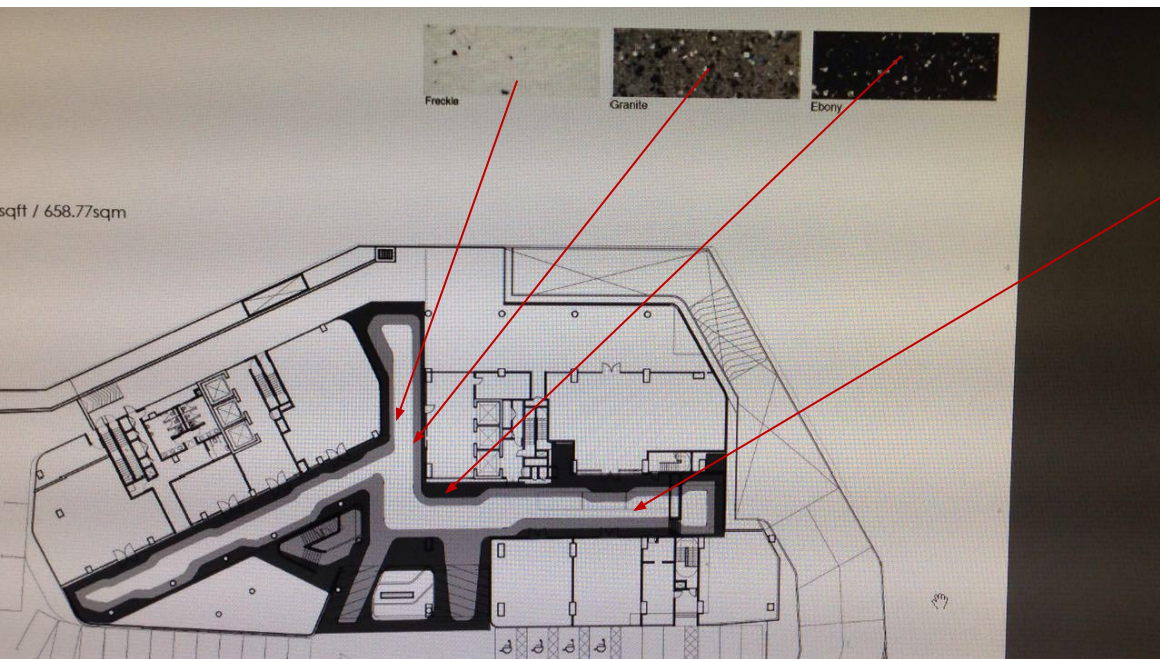
Why there has yellow patch?

No lighting at the bottom

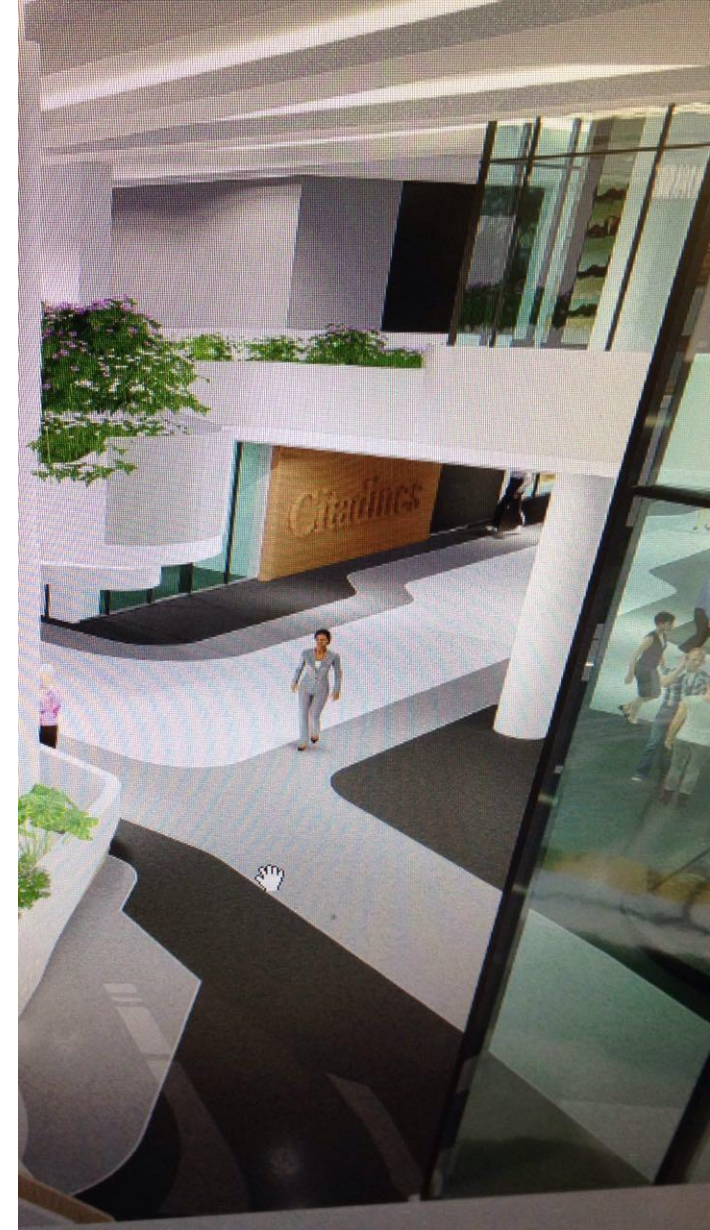
Floor pattern to follow

Light source to follow. More outdoor light

Recessed area in dark charcoal grey as per sketch up!

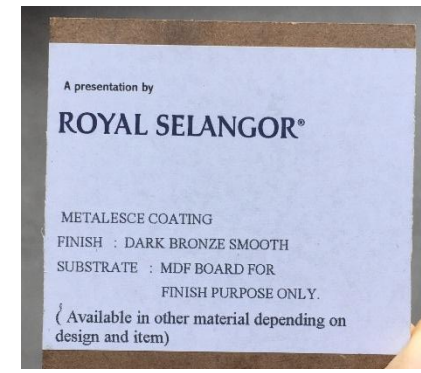
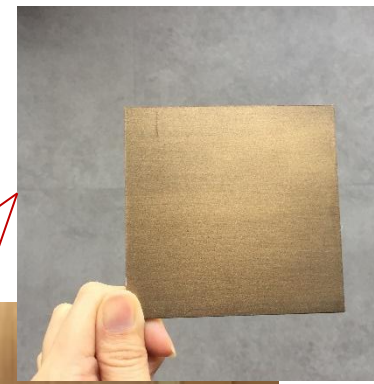
Glass door missing! To follow as per sketch up

Reception counter & "G" finishes

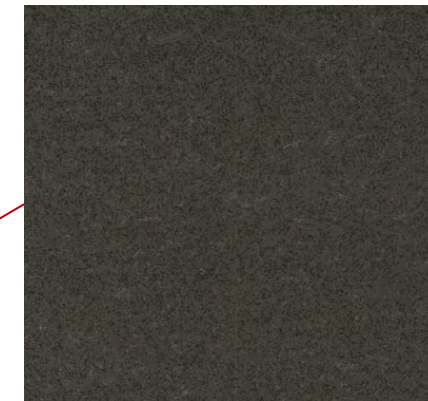
s/steel hairline Skirting missing!

300mm x 600mm tile in horizontal

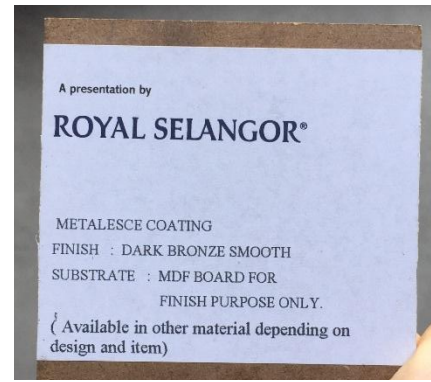
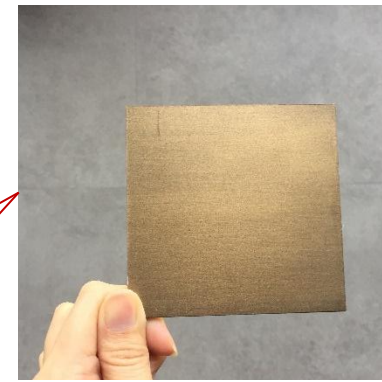
Lift car panel & lift frame & skirting to follow as per ground floor!
Pls have consistant and check within team before send out!

10mm Groove line still missing!

Deco panel & "3" signage finishes

300mm x 600mm tile in matt finish lay horizontally.
To follow as per sketch up sent out previously!!!!

Can you guys see the lighting temperature is not consistently done?
Can all visuals to standardize as per Level 3 lift lobby??

Skirting in s/steel hairline finish

Units entrance signage to update
as per latest sketch up sent!!!!
Already commented on 170301 !!!

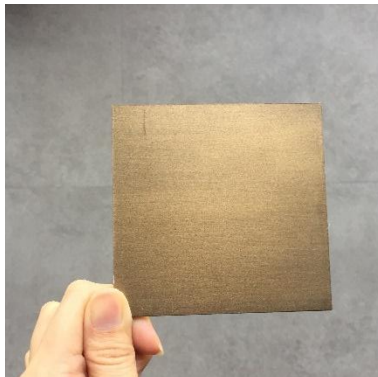
Cove light & down light
To on it!!!!

Deco panel & "3" signage finishes

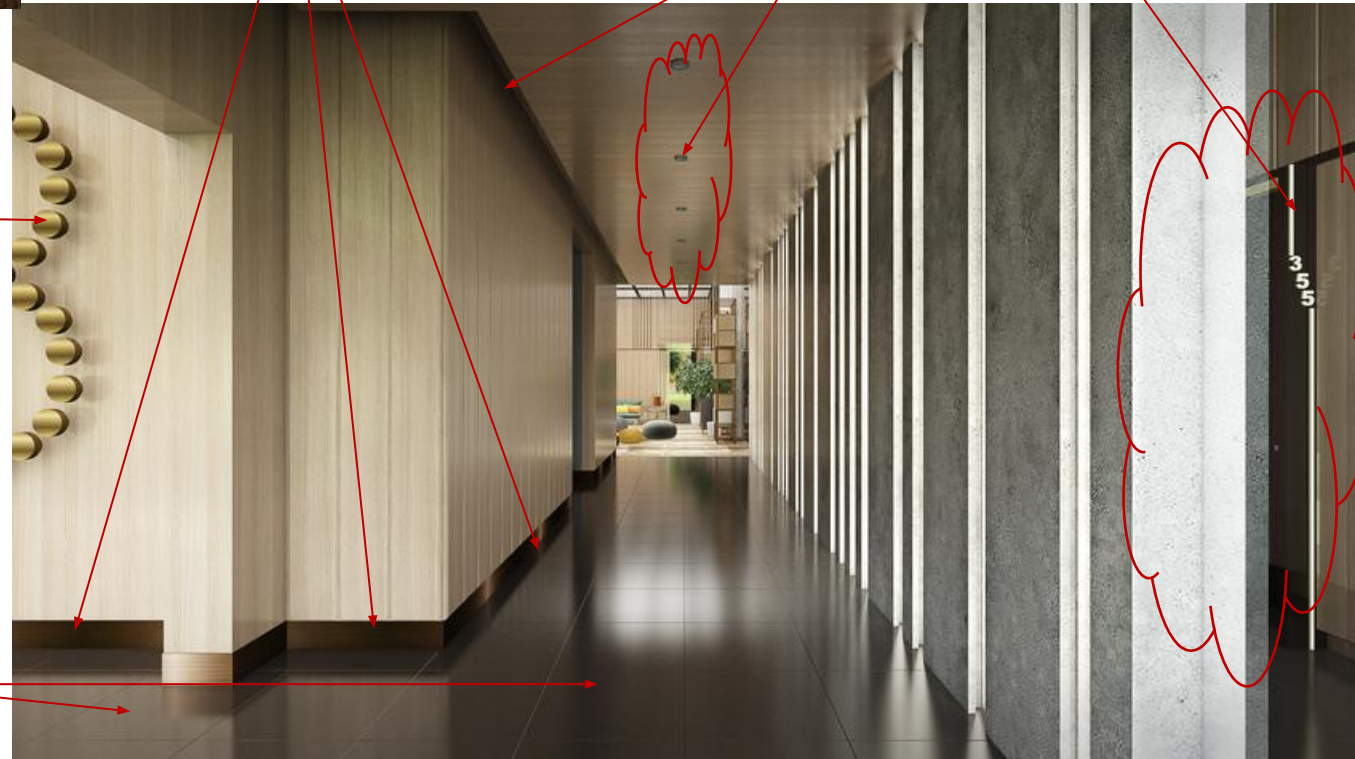
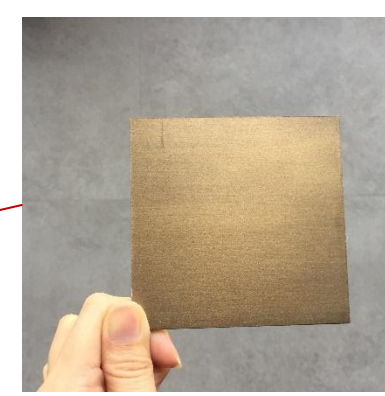
300mm x 600mm tile in matt finish lay horizontally.
To follow as per sketch red sent out previously!!!!

Reception counter finishes

Furniture arrangement still not follow as per sketch up!!!!!!

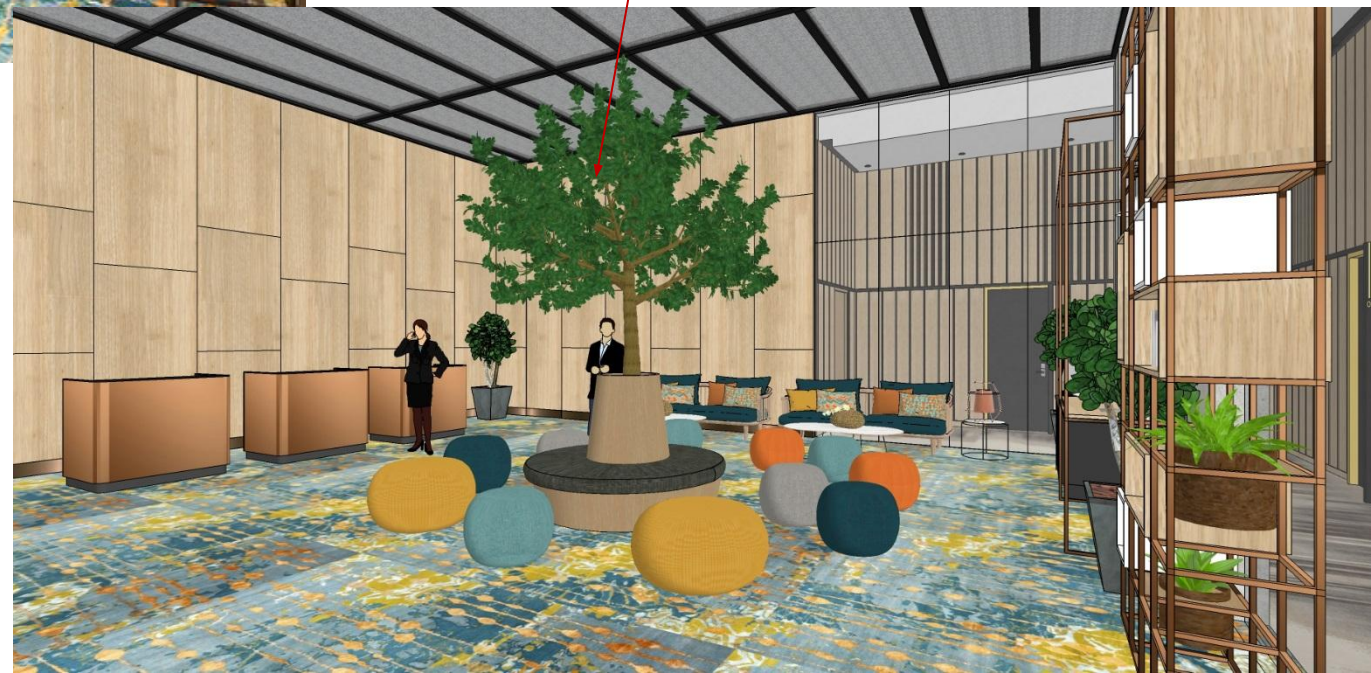
Plants to make it more volume as per sketch up!

Glass in grey tinted finish as per sketch up

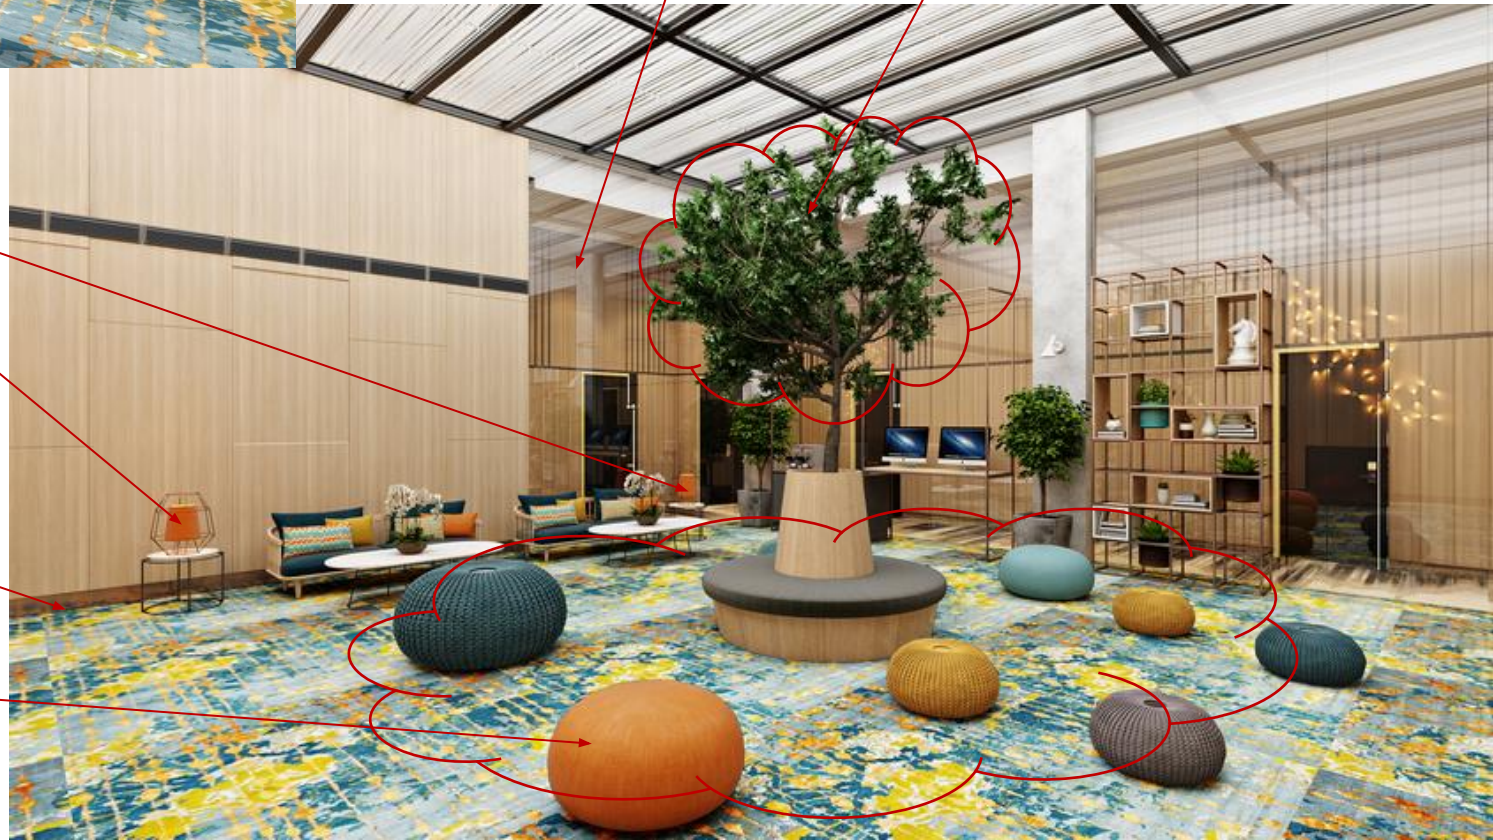
Plants to make it more volume as per sketch up!

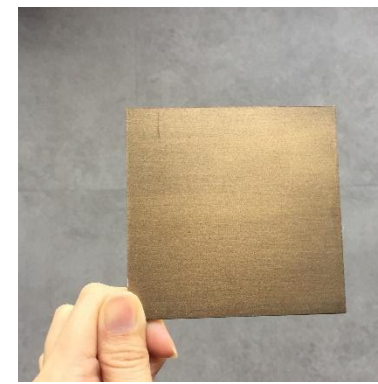
Interior light to on!

Skirting in s/steel hairline finish

Furniture scale & arrangement still not follow as per sketch up!!!!!!

Reception counter finishes

Light up the corridor

Not big tree at outdoor!
Same level as Level 3 lift lobby

Furniture scale & arrangement still
not follow as per sketch up!!!!!!

Lighting not consistent with other areas!!!!
So yellowish! Please do final check with team
before sent out!

Glass in grey tinted finish as per sketch up

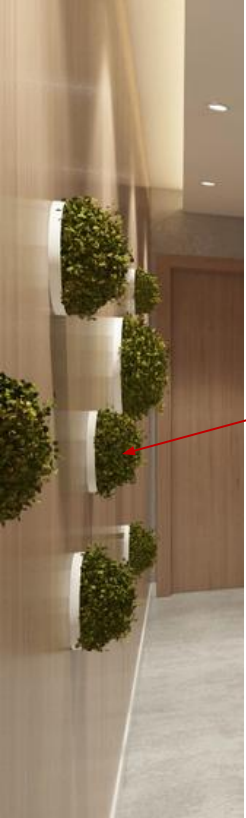
Light source temperature to have warm white as per level 3 lift lobby and to make sure all in consistent!
This lighting too white!

Plants selection to follow back as per previous!
Mirror correct!

No tree! Just sky view will do!

600mm x 600mm wall and floor tile.
Tile line missing

Make it brighter a bit. As per previous visual

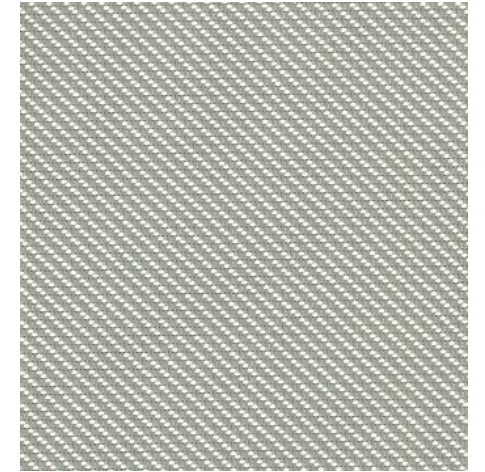
This is colour back glass! Pls show glass effect!!!!

Roller blind in light grey finish

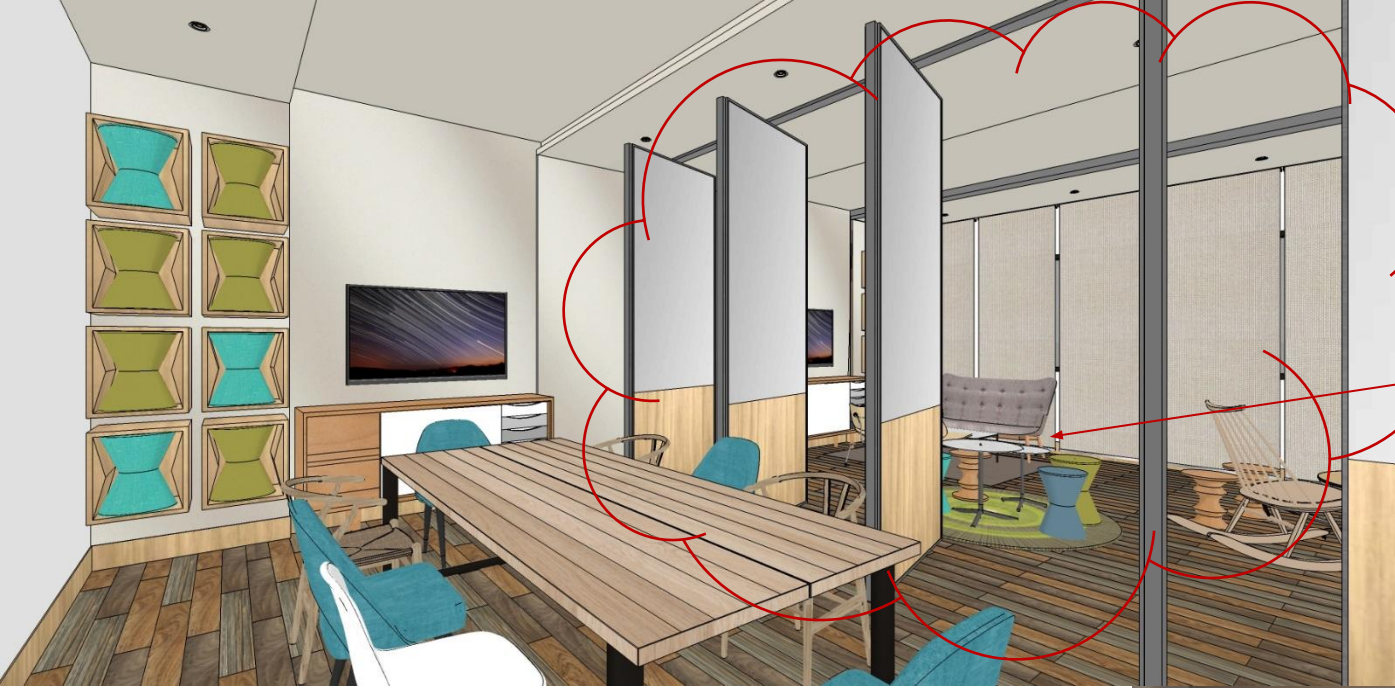
To follow as per sketch up!
To have view at another room

Chairs selection and arrangement
to follow as per sketch up
